RE: Oread Design Guidelines

Re: *Draft Oread Neighborhood Design Guidelines (the “Guidelines”)*

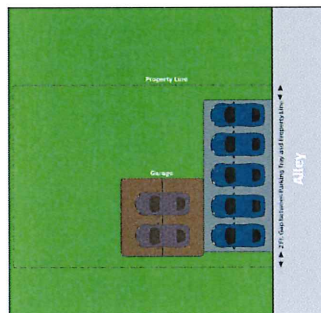
**4. The parking configuration depicted below should be re-inserted in the Guidelines because it is not “double-stacking.” This design should be an option in appropriate circumstances, determined on a case-by-case basis.**

It is unfair to completely eliminate today the possibility of allowing a Duplex more than five parking spaces in the future, especially for those properties that have been redeveloped since the adoption of the Code in 2006. The most recent draft of the Guidelines permit two limited configurations that effectively limit parking to five spaces on any Detached Dwelling or Duplex, and eliminates the only seven-car option.<sup>1</sup> The above configuration, which permits a two car garage and five outside spaces, should be re-inserted because (aesthetically, at least) it's not “double-stacking” if a garage door separates the cars. On a “case-by-case” basis, that configuration may be appropriate in the future.
